From: Aaron Sutherland <aaron@sutherlandplanning.com.au>
Sent: Friday, 29 August 2014 1:07 PM
To: Rachel Lonie
Cc: Natalie.Bernuetz@aspect.net.au; Matthew Rosel; Chris Ryan; jhanley@imanager.net.au
Subject: RE: Kirrawee Brick Pit - MOD 3 - Response to Submissions (revised project)
Attachments: 13066_Kirrawee Brick Pit_S75W_07_B- STIF Comparison.pdf; Kirrawee Ecology Letter V2.pdf; STIF Comparison_response to Dept Planning.docx

Response to Office of Environment and Heritage letter;

DOC14/139795, Rachel Lonie, 18/08/2014: OEH comment on re-exhibition of the Concept Plan Modification for the Kirrawee Brick Pit Site, Princes Hwy, Kirrawee (MP10_0076 MOD 3)

KIRRAWEE ECOLOGY LETTER: POTENTIAL IMPACTS TO STIF

STIF Impacts Comparison

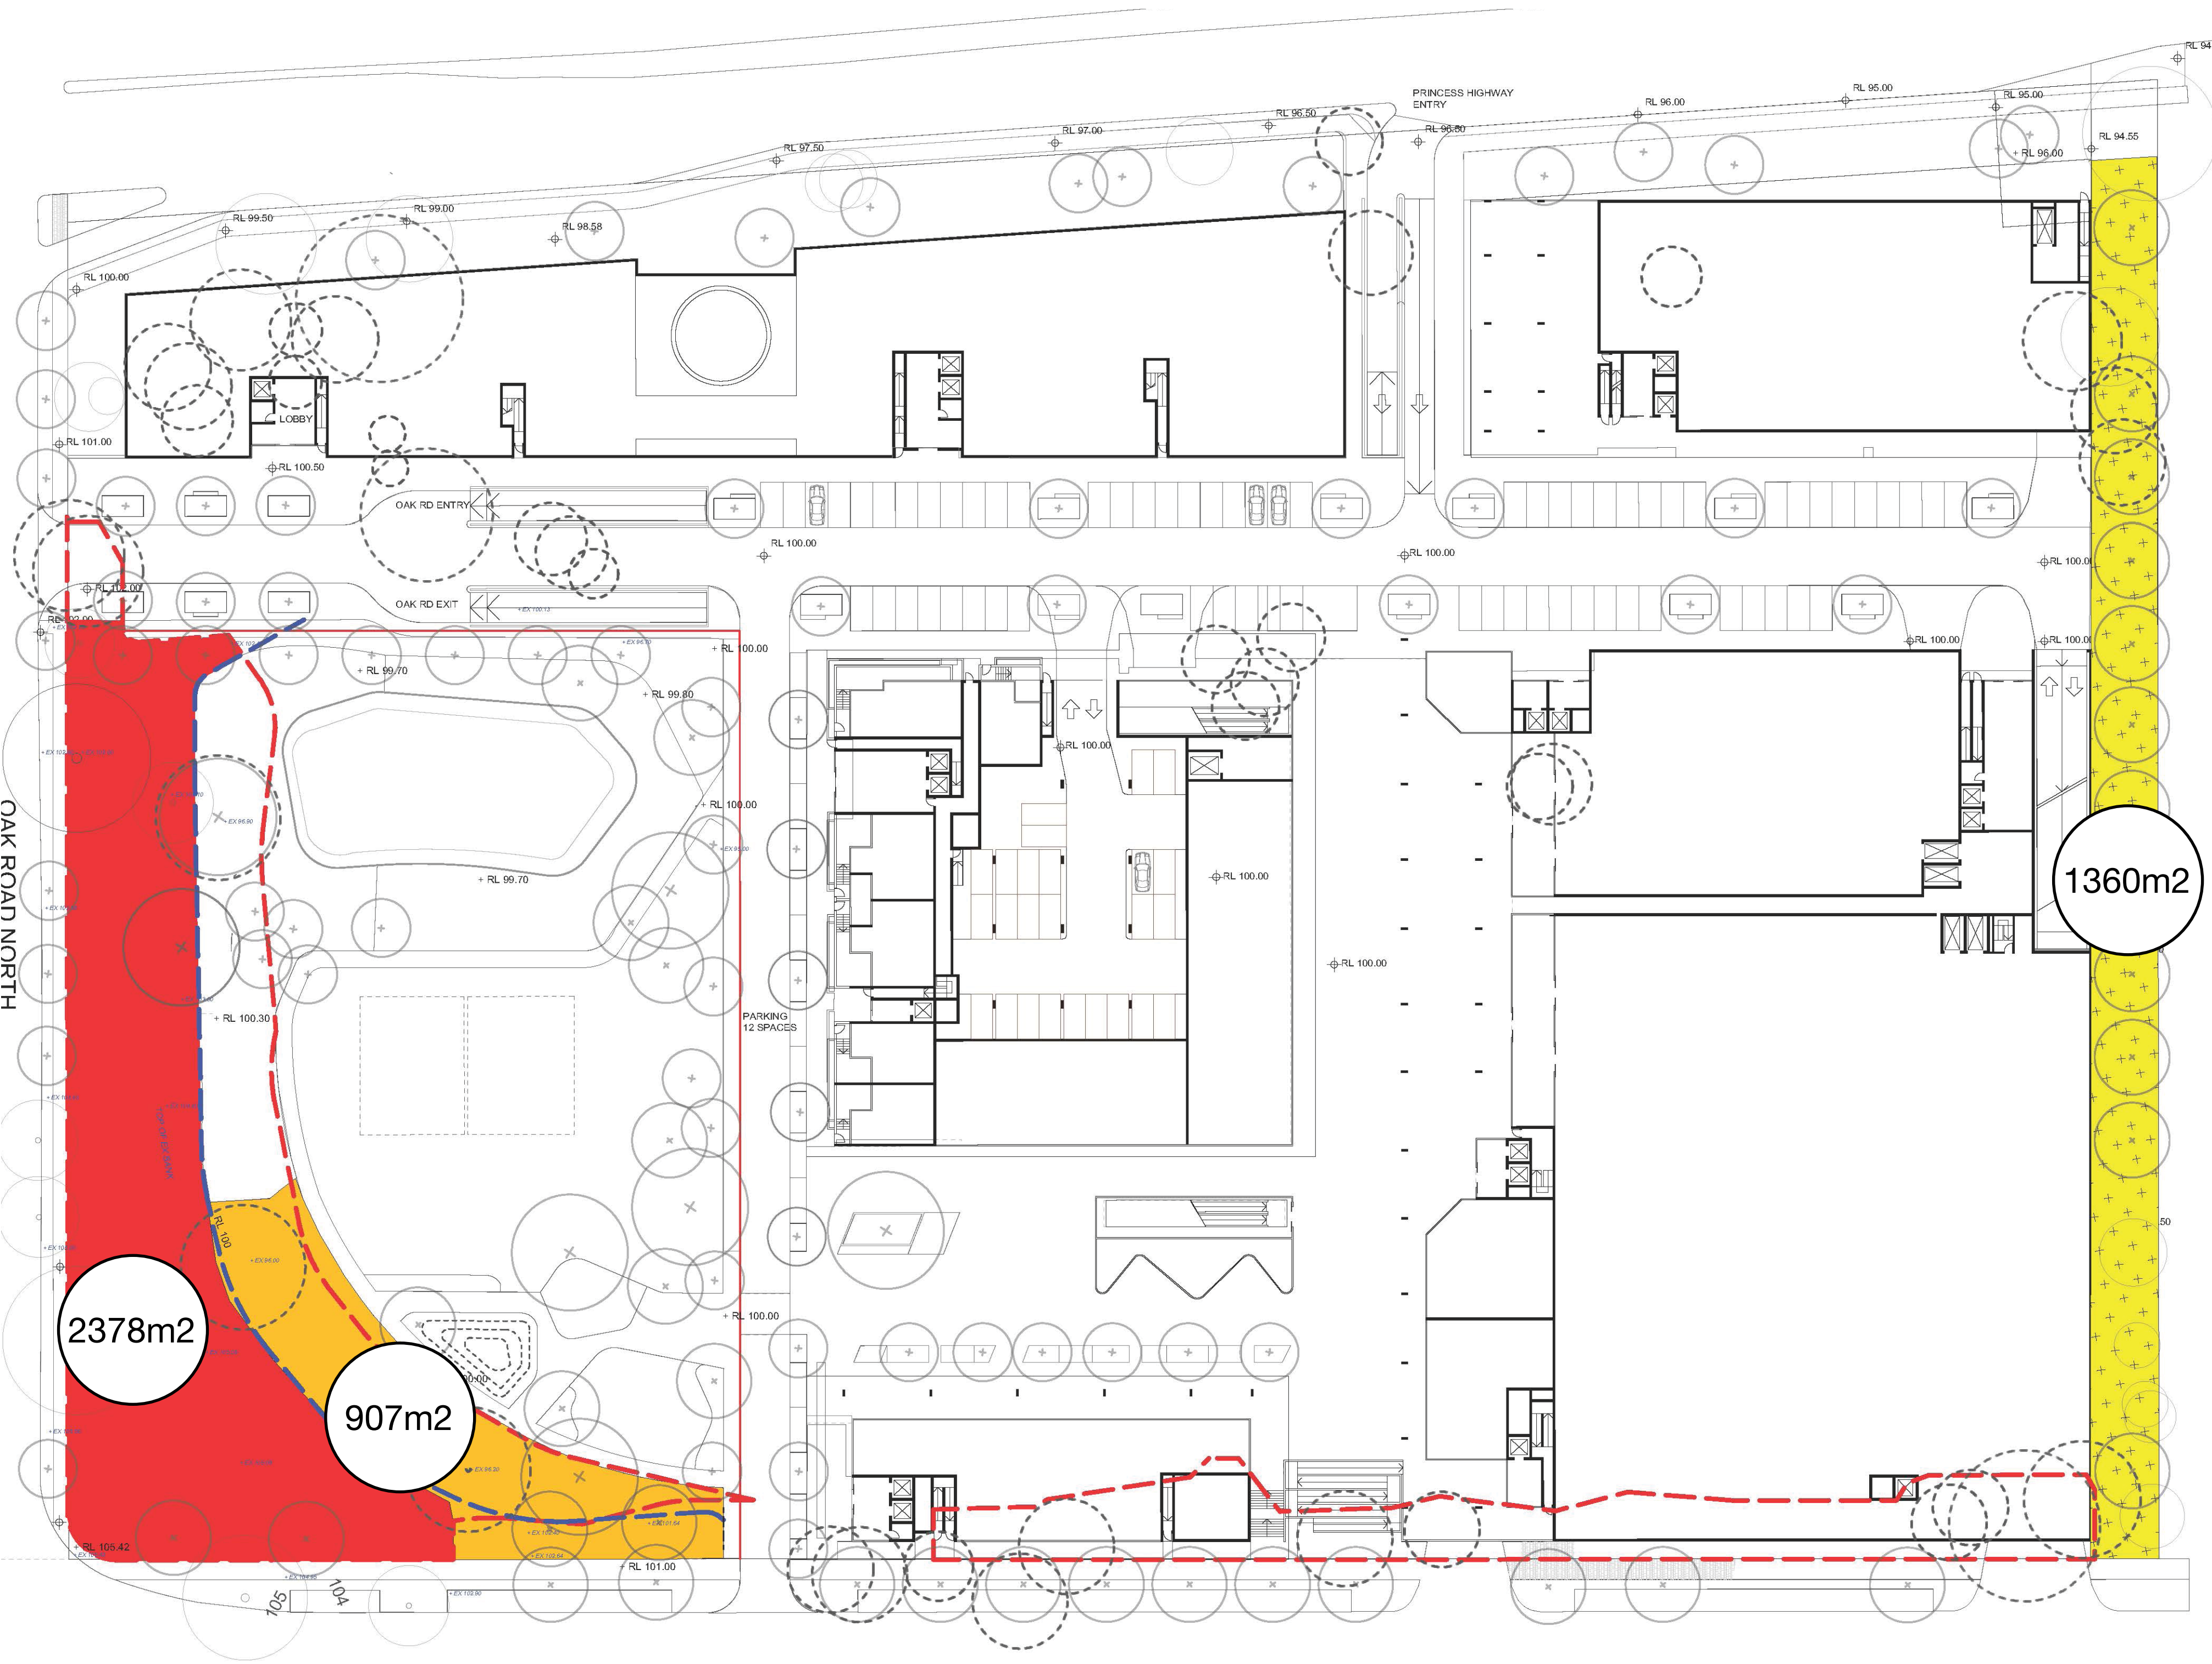
The *ST/F Impacts Comparison Plan* (dated July 2014) is however at variance with the approved Concept Plan in terms of retained STIF on original soil area, STIF to be reinstated and the compensatory STIF bushland off-site offsets.

Areas mapped in the *ST/F Impacts Comparison Plan* in red and orange are labelled 'STIF to be retained' and 'STIF to be reinstated' respectively. Differences to the original mapping are that the red is larger than the area originally mapped as 'STIF on original soil' and the area mapped in orange is now less than half the original 'retained STIF regenerating on quarry walls'.

There appears to be no justification for reducing the northern section of the area on the quarry wall from the retained STIF area, although OEH notes that the Schematic Water Management Diagram shows that the constructed wetland

OEH considers that the areas identified to be retained both on the original soil and regenerating on the quarry walls should not be reduced in size. Retaining STIF vegetation around the waterbody was originally intended to provide habitat for the Grey-headed Flying Fox (GHFF). The *Addendum to the Biodiversity Management Plan* for the MOD 2 (approved 16 May 2014) states in Section 2.2 (iv)(iii) that the pond must be located adjacent to suitable roosting habitat for GHFF.

OEH does not consider the indicative landscape plan clearly provides a plan for STIF vegetation to be retained, protected and reinstated as originally proposed. Inconsistencies in the information presented and the lack of detail does not provide assurance that this will be the case. For example, in the photomontage 1 - *Near Oak Road and Flora Street* it appears that the retained STIF area is largely grassland. The photomontage 3 - *New Park and Lake* shows that STIF area to be reinstated on regraded batters is largely boulders and grassland/shrubs rather than a reinstated full ecosystem with canopy and mid storey species. This is reinforced through information presented in the section AA that shows only grasslands in this zone.

The area mapped in yellow and identified as '*STIF to Eastern Boundary*' is a landscape area only already identified in the approved Concept Plan as an 8 metre wide landscaped edge. OEH considers this additional area cannot be considered to be STIF as the area has not been identified as STIF habitat and is already approved as a landscaped area.

The reduction of compensatory STIF bushland to 2509m² is also not justified. The Biodiversity Offset Package was a condition of approval for the Concept Plan and provided for a minimum of 5,300m² of replacement STIF replantings at sites to be agreed upon by Council and OEH. Even on the current reassessed STIF area to be removed (i.e. 2388m² down from the Approved Concept Plan amount of 3296m²), 4,776 m² of compensatory STIF offsets are required. OEH considers that the impacts on STIF need to be fully offset and that the eastern landscaped edge should not be used in this

The area shown red is STIF to be retained (on original soil, as well as regenerating on quarry walls).

The area shown orange is new STIF, reinstated to areas where regrading of the site has required removal of STIF. This should not be confused with 'retained STIF regenerating on quarry walls'.

To the southern end, we have proposed reinstating the STIF area with new compensatory planting (shown orange), and to the north, new swale planting.

All areas of STIF at RL100 and above will be retained.

The total area of existing STIF to be retained on site (both on original soil and regenerating on quarry walls above RL 100) is 2378m²; 405m² greater than the ecology report at 1973m².

The photo-montage, sections and colored plans are indicative illustrative content for the DA submission. We have included a STIF comparison plan and table, S75W- 07, to clearly outline the proposed areas of STIF to be retained, removed, re-instated on site and provided as compensatory planting off-site.

This area of compensatory planting is calculated 'in addition' to the 5300m² replacement provided off-site. If not considered viable as STIF habitat, it will be provided as a landscape buffer.

The table is misleading, and assumed that replacement areas on site would form part of the total of 5300m² compensatory planting required. This is not the case, please refer to the attached updated plan and table.

Total STIF to be removed is 2388 (405m² less than the approved concept)

Total STIF compensatory planting off-site is 5300m² (no change. Please note that this is above the 2:1 ratio based on the total to be removed)

Total STIF compensatory planting on site is 2267m² (or 907m² if the eastern boundary is not a viable option. This total is in addition to the requirement of 5300 off site)
